Technical Bulletin

Bulletin Number: 441 Revision Number: R-00

SUBJECT: EXTERNAL RETAINING RING (E-RING) FOR T-HANDLES

MODELS AFFECTED: All Models

Figure 1

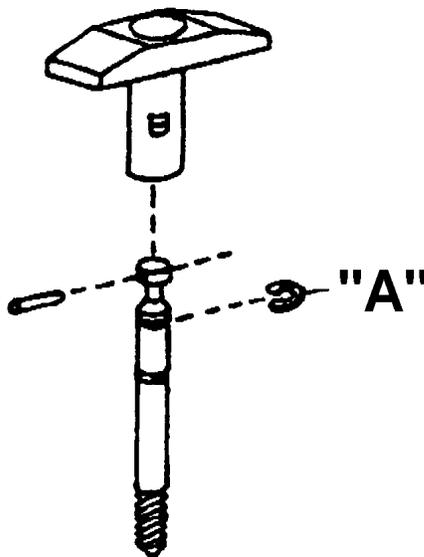
REASON: To make available an E-ring with increased strength to combat vandal entry by prying door.

External Retaining Ring
Part# 801,507,340.01

1. Remove T-handle from T-handle body.
2. Remove existing E-ring. See section "A", figure 1.
3. Install new external retaining ring in its place.
